Access Compliance Report

Public Rights-of-Way

Intersection ID: N/A	Main Street: ANSLEY GARDEN DR	Cross Street: ZILKER PARK DR	Location: W
ADA ID: 43A0F8DDEFEC	Ramp Type: Perp	Initial Pass/Fail: Pass	Overall Compliance: No
Codes/Mitigation Info/Possible Solution		Field Measurements/Component Compliance	
Severity Score: 12.5

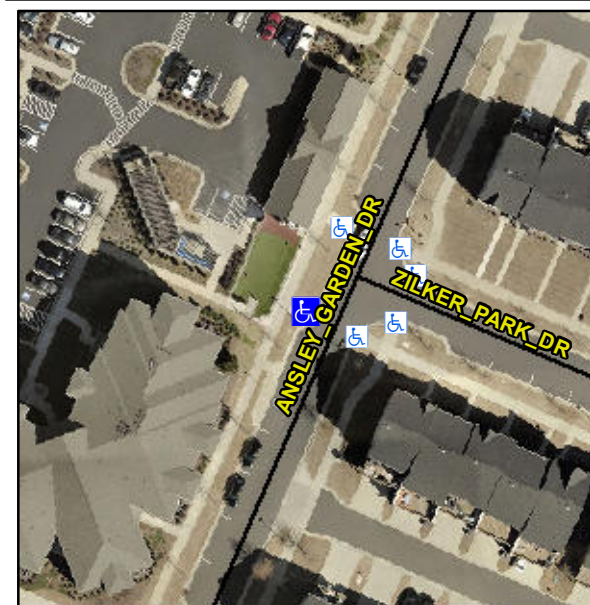
Remove & Replace Gutter.

R302.7.2, R304.5.4, R304.5.3
